E8362BH85-02A

S E R V I C E N O T E

E8362BH85 PNA Microwave Network Analyzers

Figure 1: A3 Front Panel Interface Board Assy without the Bracket

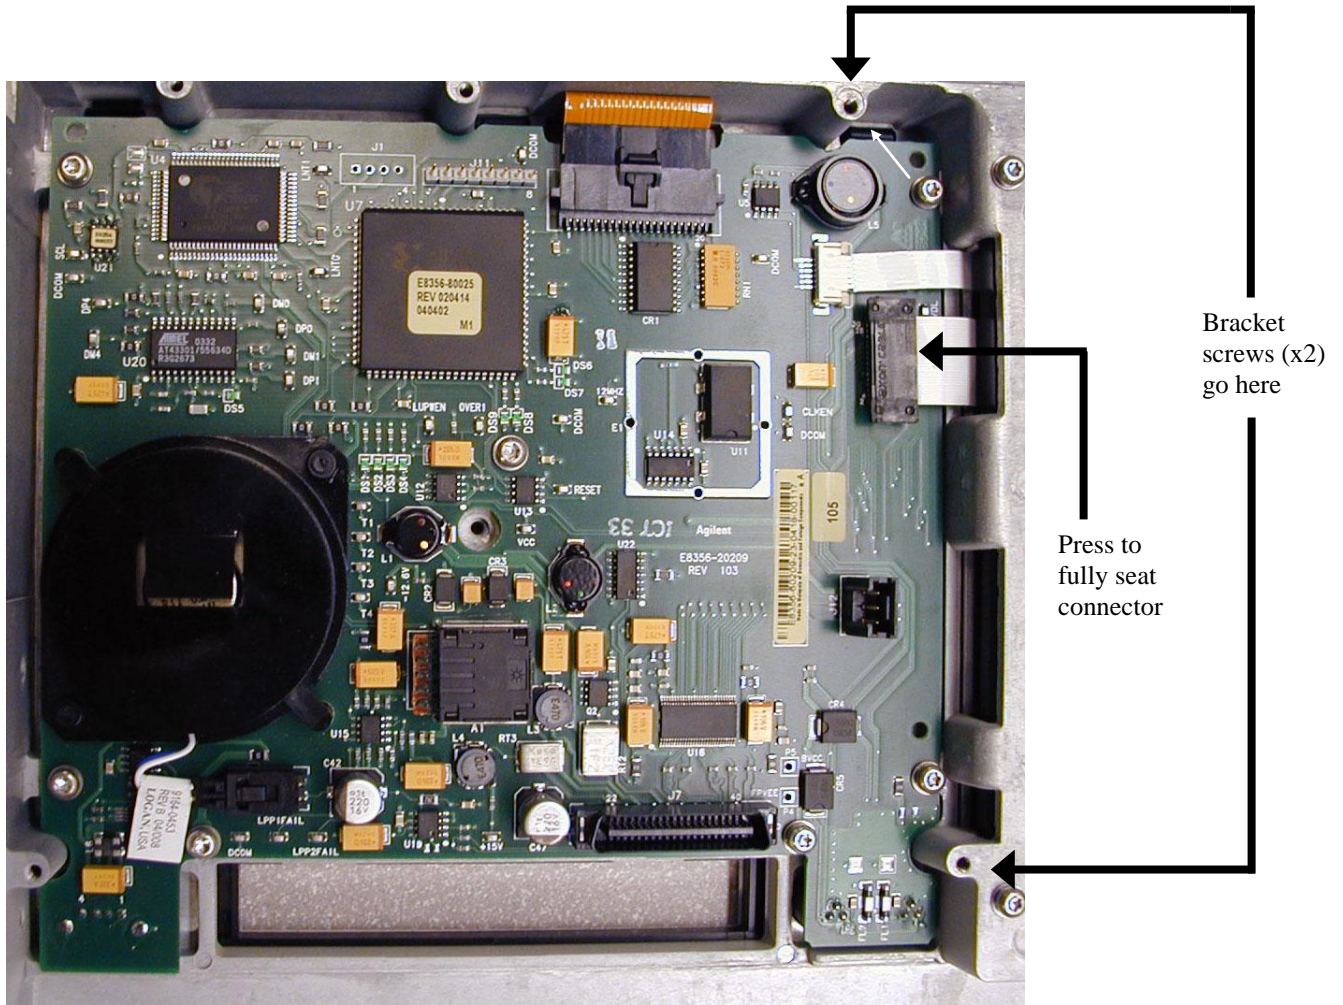
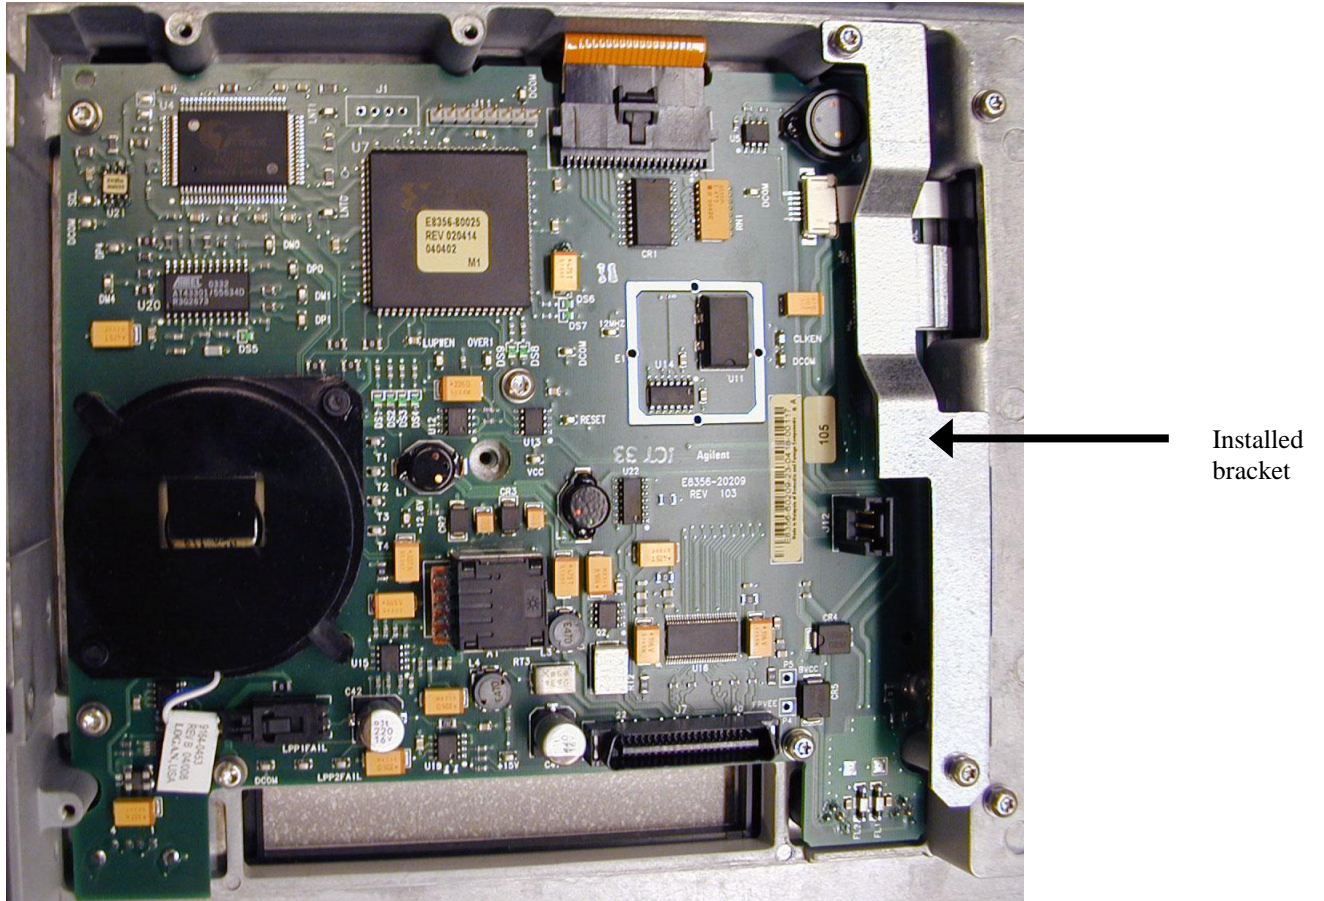
A connector of the ribbon cable (Agilent part number 8120-8409) that joins the front panel display to the front panel interface board can loosen, causing a display failure, unless a new bracket is installed. Because the failure rate has been very low, it is recommended that the bracket be installed only when there is an additional reason to remove the PNA front panel.

1. Refer to Figure 1 in this document:
 - Press down firmly on the ribbon cable's black connector.
 - Locate the two tapped holes for the bracket screws.
2. As shown in Figure 2 in this document, position the bracket so that its holes line-up with the two holes you located in the previous step.
3. Hand-start the two screws, and then torque both to 9 in-lbs.
4. Reinstall the PNA Front Panel by following the Service Guide instructions in the "Replacement Procedure." This is located on the same page as the "Removal Procedure" used previously in step 7.
